## ***Interactive comment on “Geophysical and Geodetical Investigation of A Landslide Area (Koyulhisar-Sivas, Turkey)” by Sevda Özel et al.***

REVISIONS Dear Editor

RESPONSES:

Figure 8. EM wave velocity calculated for reflection surface in GPRS in the C-east area cross section as representing all the GPR profiles.

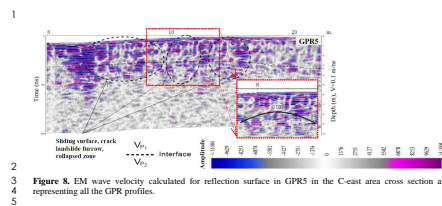
Response for Figure 8 and 10 I rearranged Fig. 8 and 10. I named as Fig. 9-10-11 all of them -the figures after Fig. 8. I rearranged the figure numbers in the article text. Other corrections:
